## PRODUCT SERVICE BULLETIN

We issue the PSB 001/2016 in accordance with some pilot's requests, needed to much force to pull out the spectra ripcord. We recommend a measuring and pull force test to be performed before next jump. Ask your rigger to do it. Replacement of the Ripcord must be performed on next scheduled repack.

Fig. 1

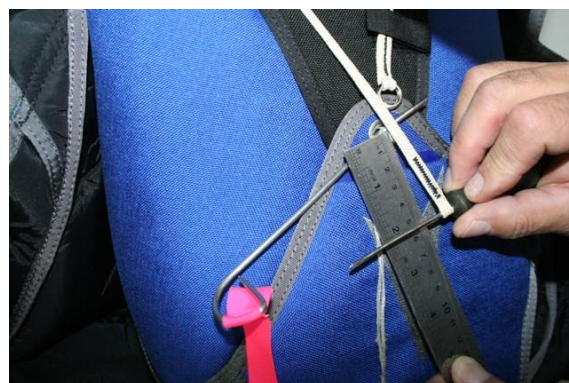
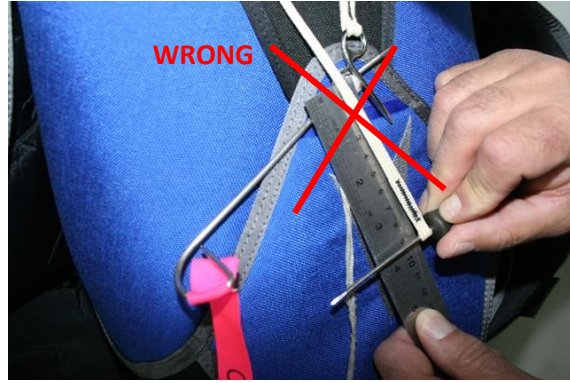
2. Pull fully the Spectra line and measure the length. It should be between 1 <sup>1</sup>/<sub>2</sub>" and 2" inches (5, 5 cm) from the loop to the end of the line. But not more than 2" inches (Figure 1 and figure 2)

3. If the length is more than 2" (5,5 cm) please contact our team for future assistance.  
info@avalonskydive.com

**!!! MAXIMUM ALLOWABEL PULL FORCE ON THE RESERVE RIPCORD IS 22 POUNDS (10 KG ) !!!**
